**TOWN OF AMHERSTBURG
DRAINAGE BOARD
Tuesday, December 7, 2021
6:00 PM
ELECTRONIC PARTICIPATION
MINUTES**

6. CONSIDERATION OF FINAL DRAINAGE REPORT

6.1 3rd Concession Drain North – Bridge for Blais

DRAWN BY: G.S. & K.D.
PLOT CODE: 1:1
COMPUTER FILE: REI2021D010.DWG
FILE No.: REI2021D010
SHEET No.: 1 OF 2

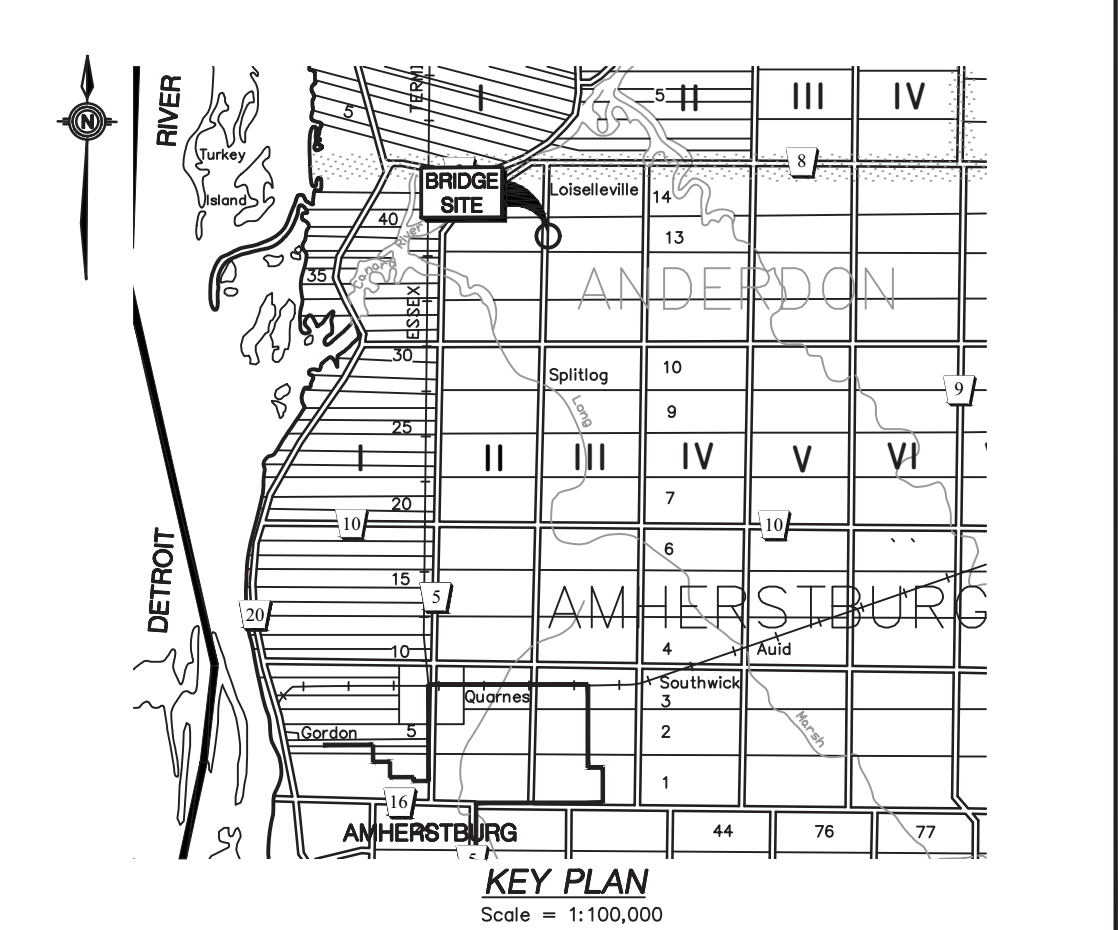
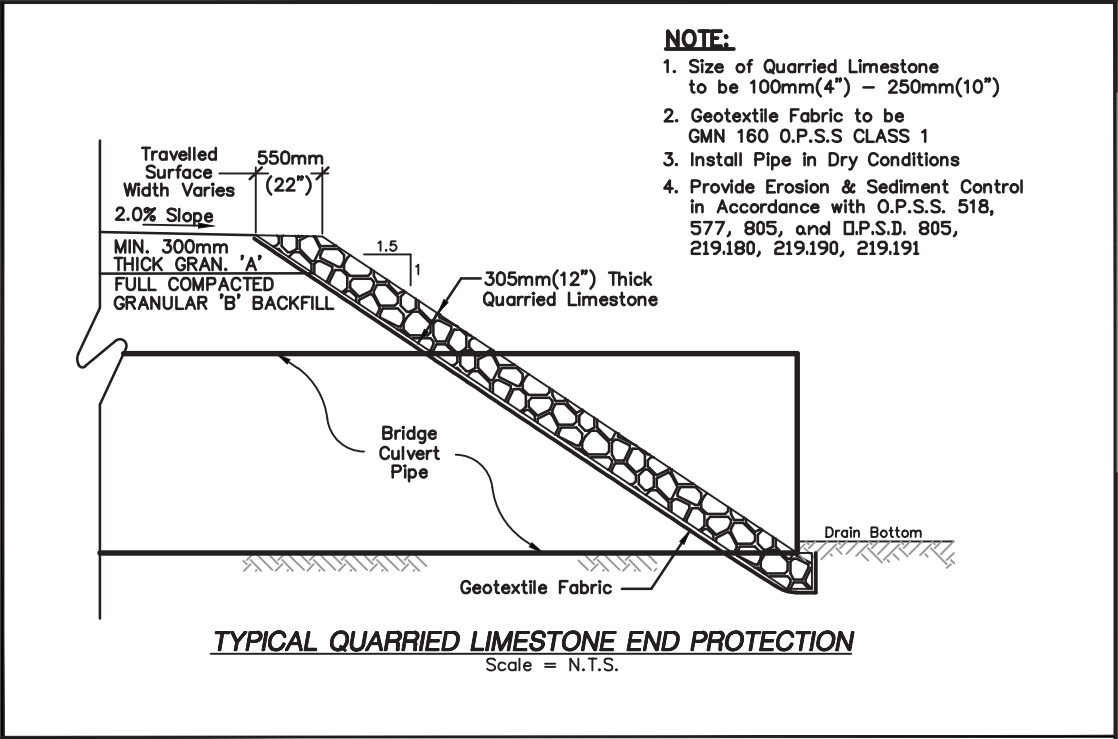
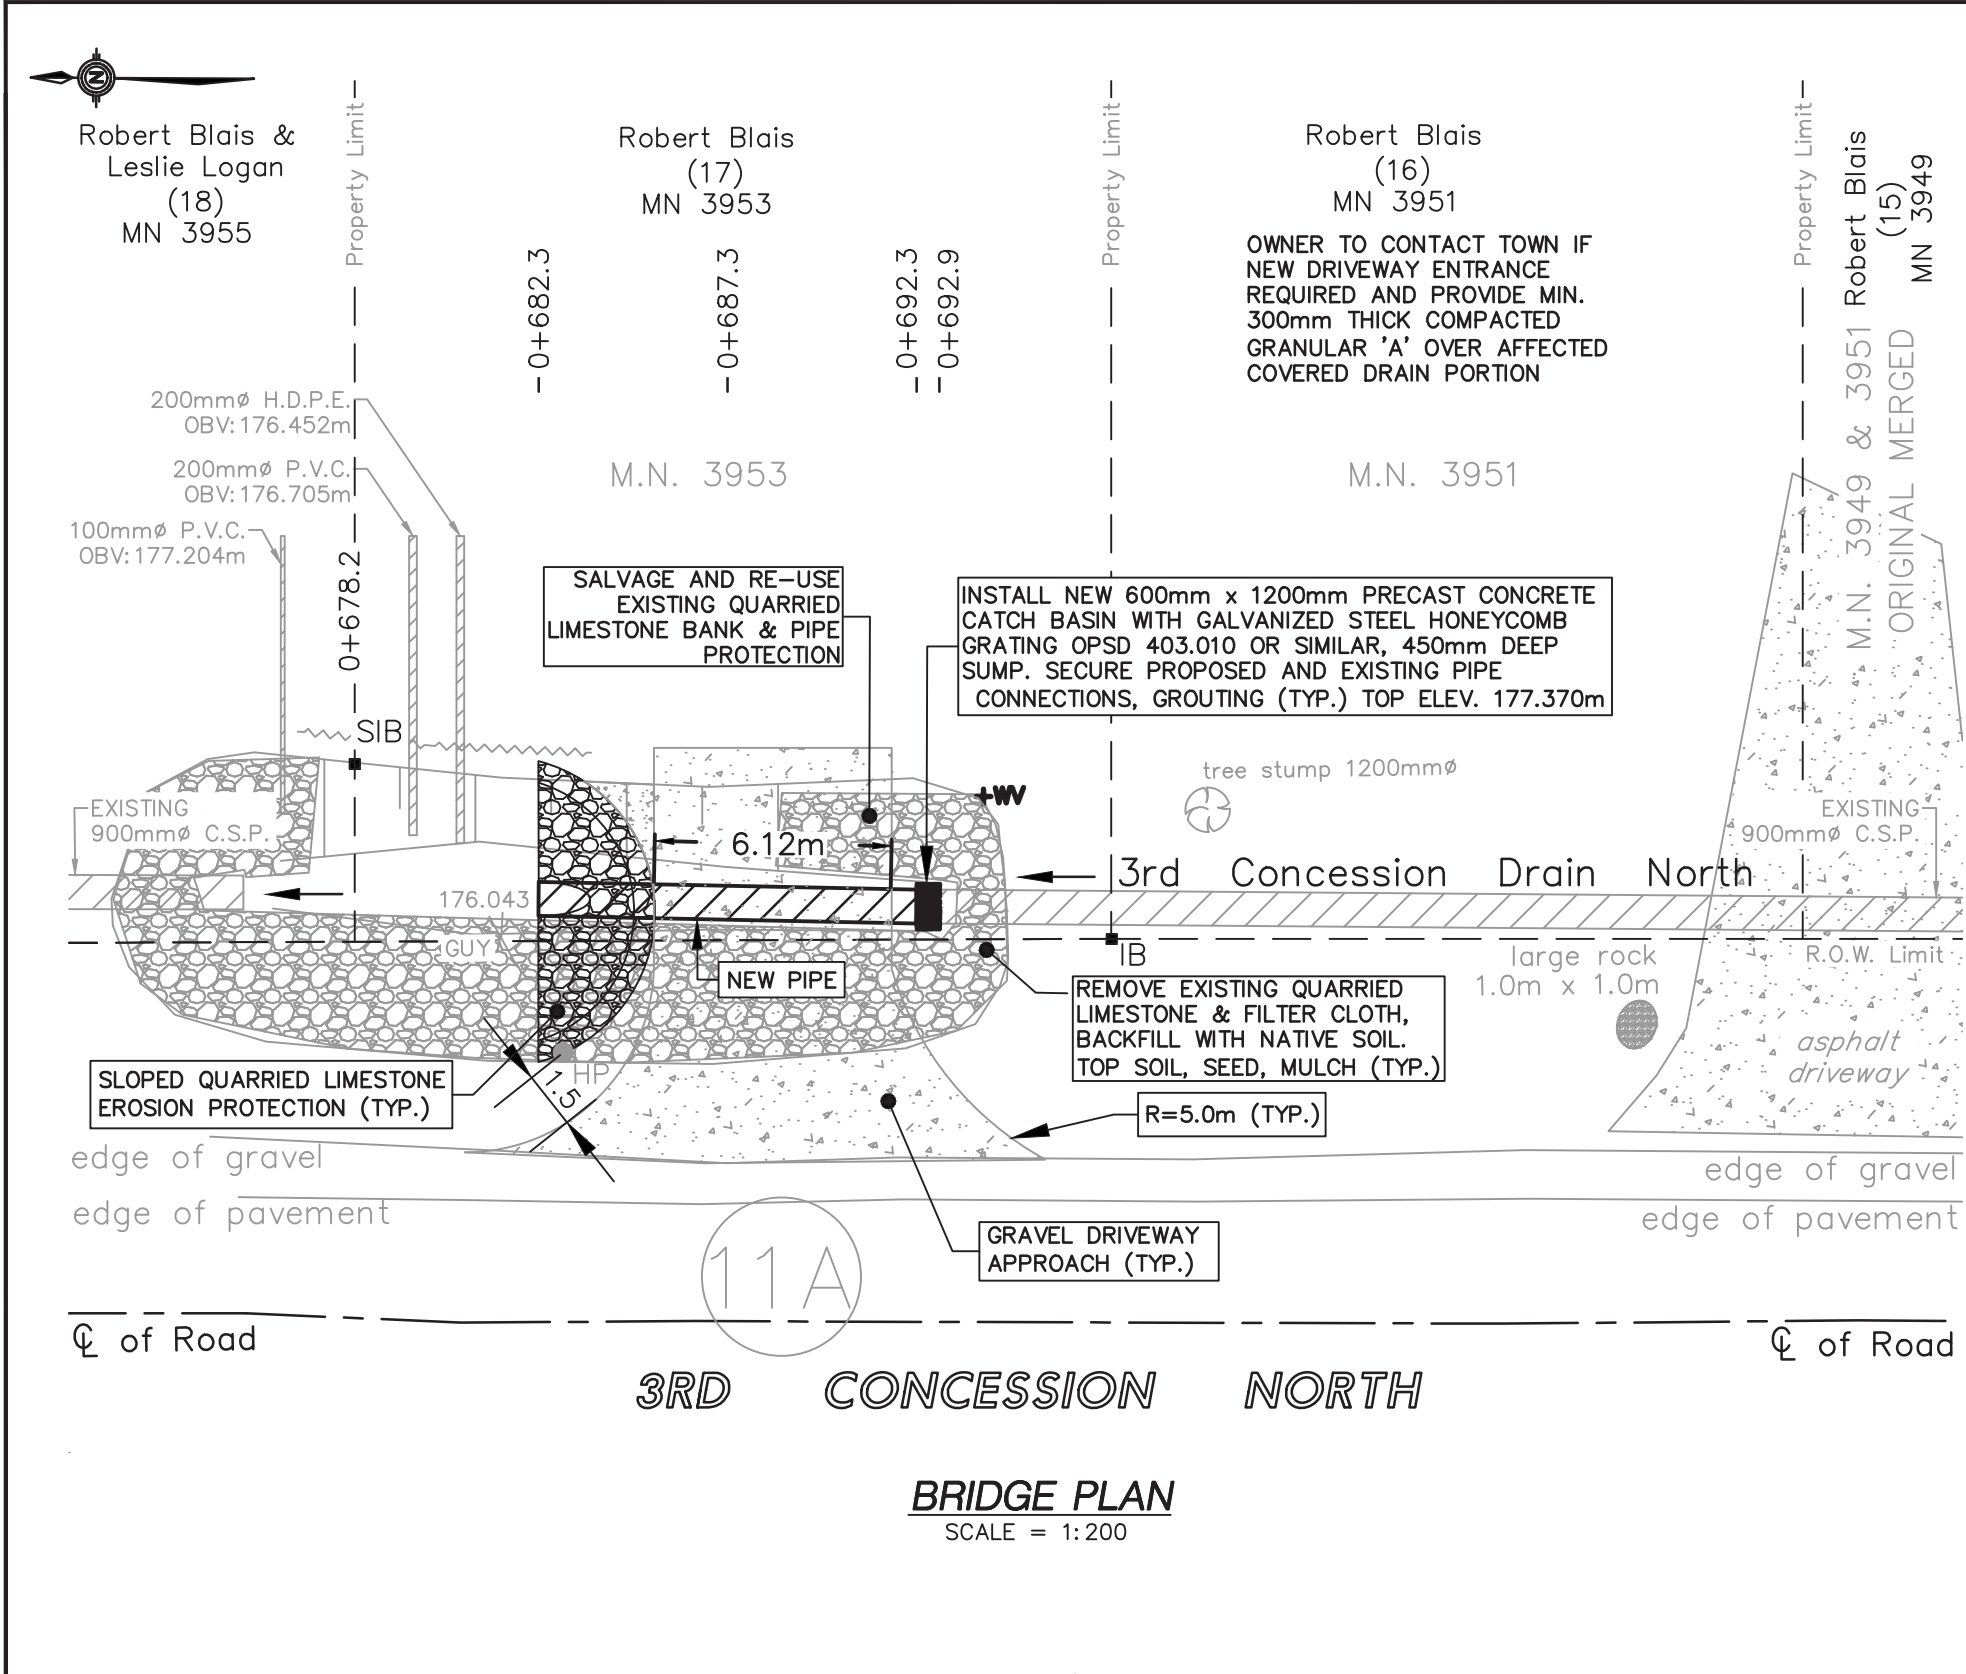
Board member Anthony Campigotto noted that there was a discrepancy in the top-width between the plans and the specification portion of the report.

Mr. Rood explained that there was a typographical error within the specification, which indicated a top-width of 6.95m. The plans show the top-width to be 6.12m, which is the correct dimension. Mr. Rood further explained that he would provide an amendment to the specifications to reflect the 6.12m top-width that which will be consistent with the plans.
